Friends of Cherokee Marsh & Upper Yahara Watershed

Response to DRAFT Cherokee Special Area Plan

Overview Map

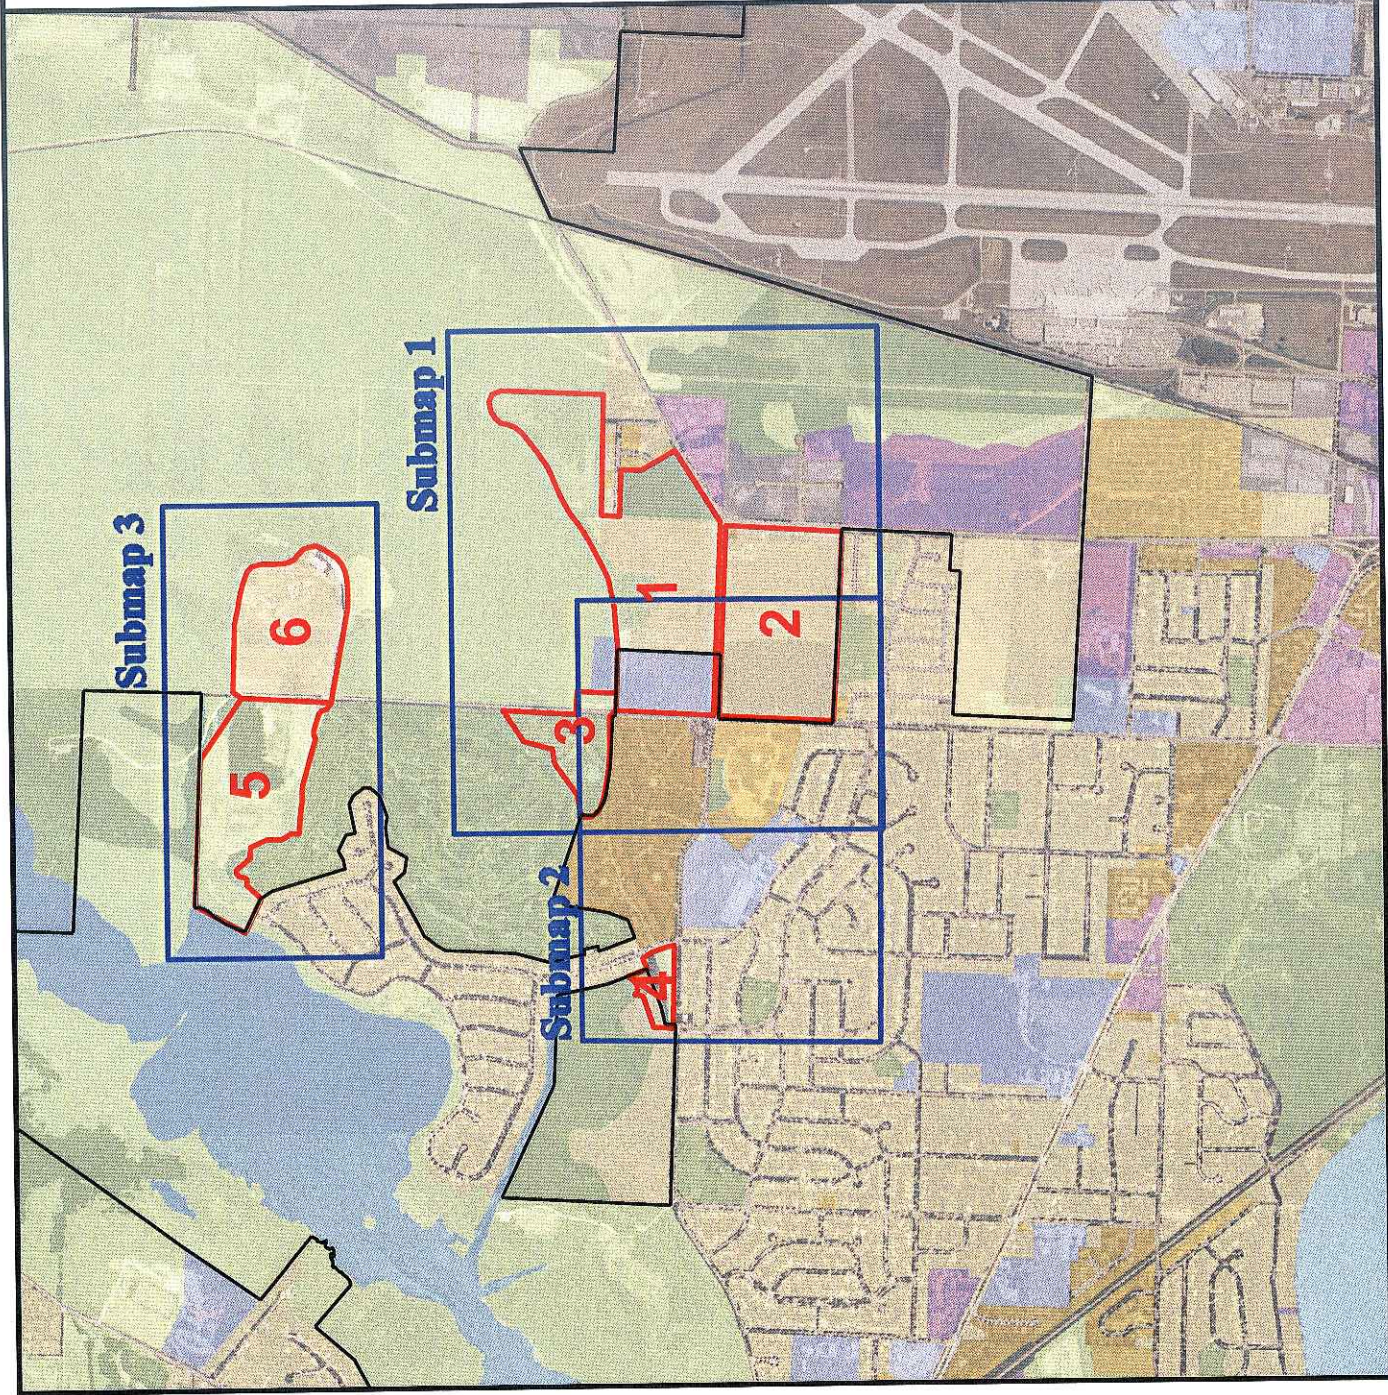
FoCM proposes that the DUs planned for Subarea 1 (242), SubArea 4 (24) and Subarea 5 (5, potential future development area), be transferred into a 35-45 acre portion within the eastern two-thirds of Subarea 2, currently mostly cropland.

Even if all those DUs were added to the 338 DUs already proposed for Subarea 2, the total DUs would be 609, creating an average density ranging from 13.5-17.4 DUs/acre, close to the City's Low Density Range (8-15 DUs/net acre) designation for much of this area in the SAP.

Based on WRNA input, FoCM tentatively recommends limiting average density in SubArea 2 to an average 11 DUs/acre, while also taking steps to

Submap 3

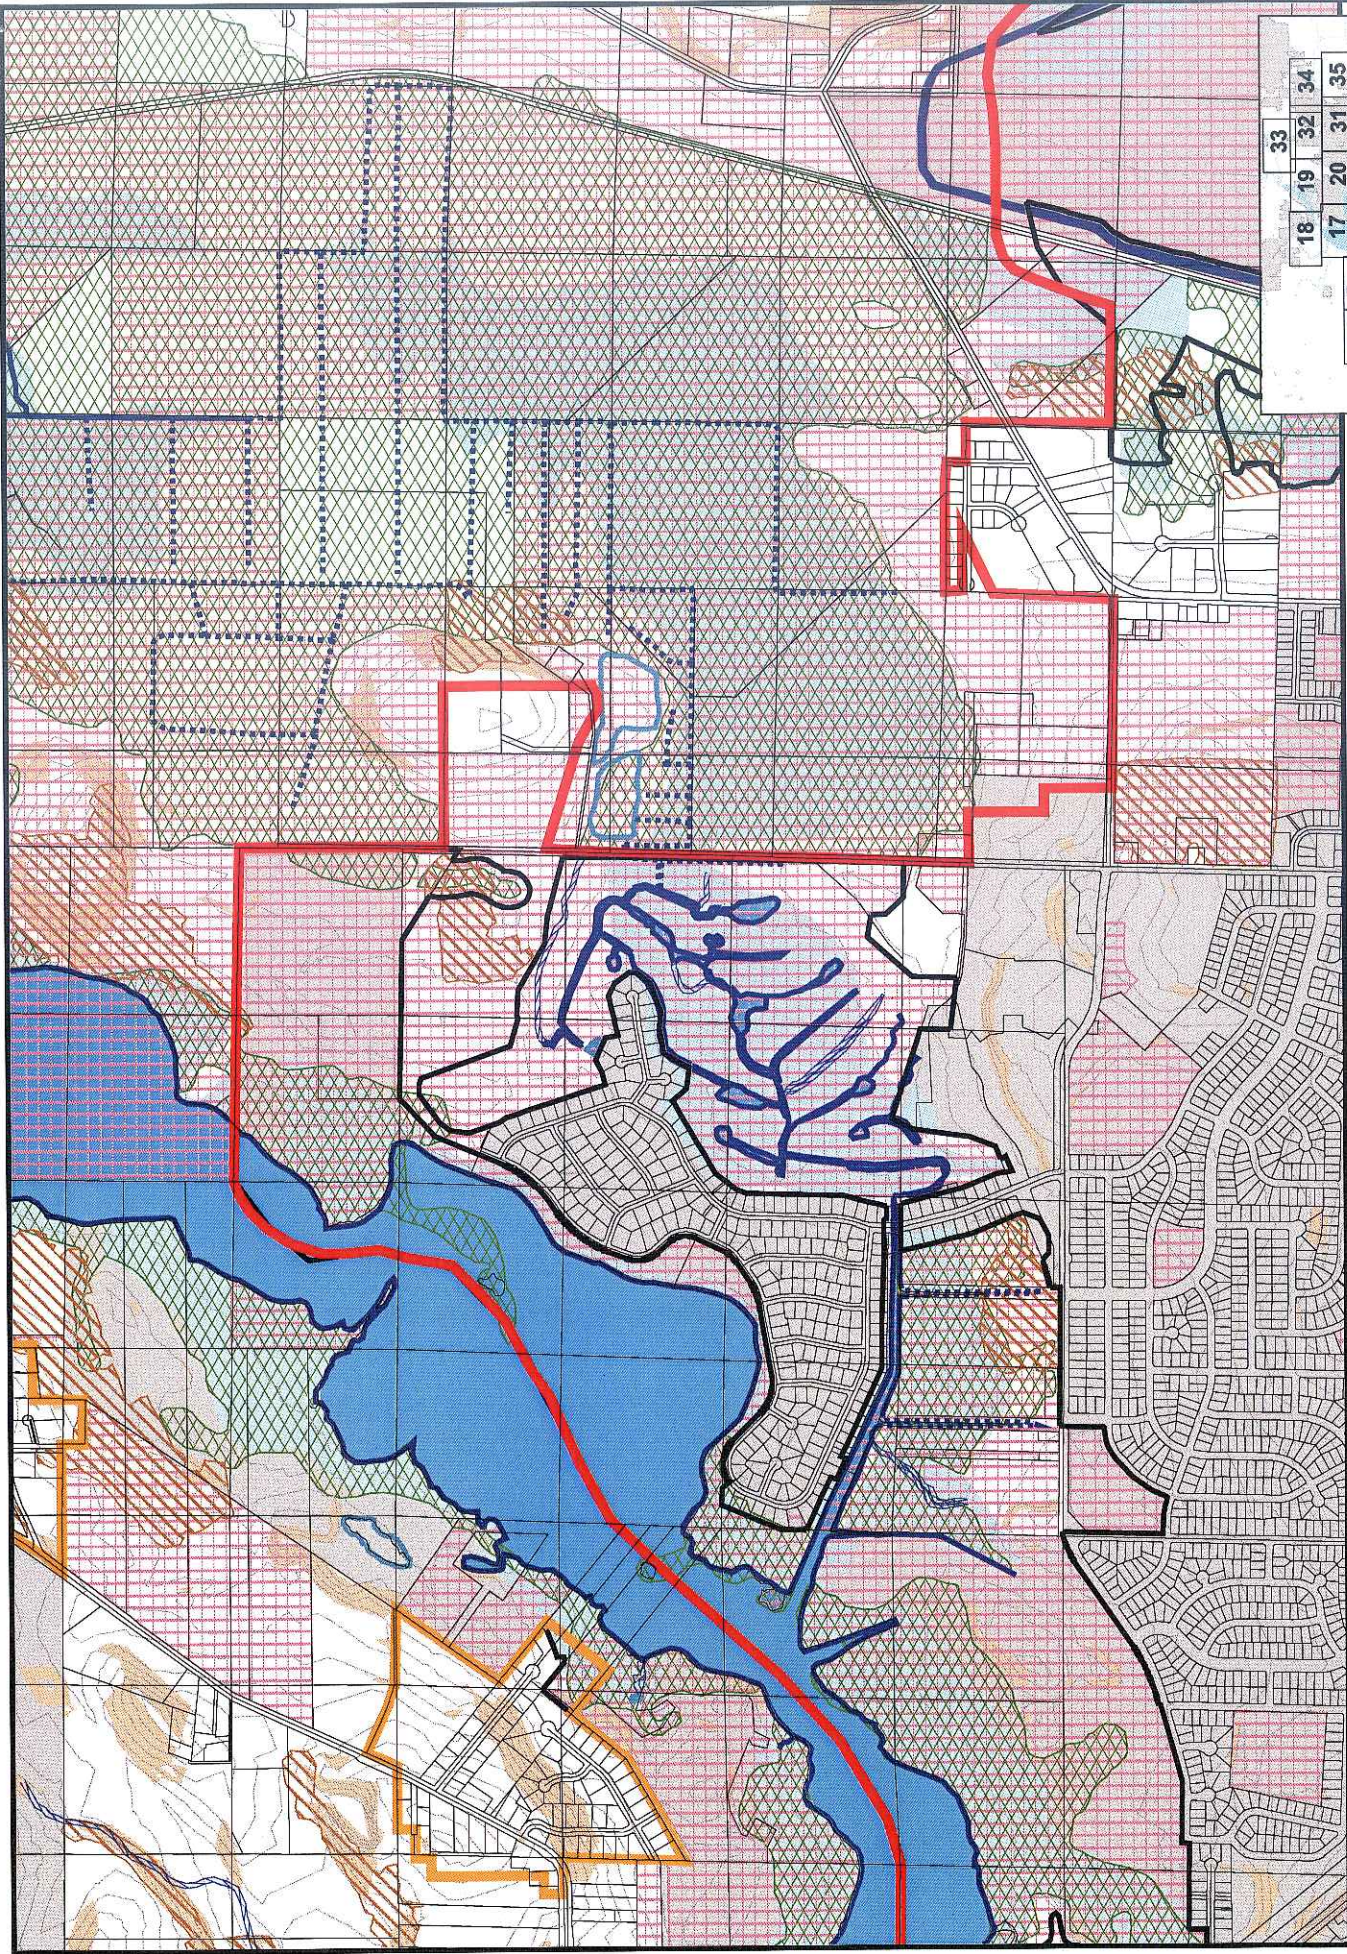
4-alt
Relocate proposed
DUs to Horning Fields
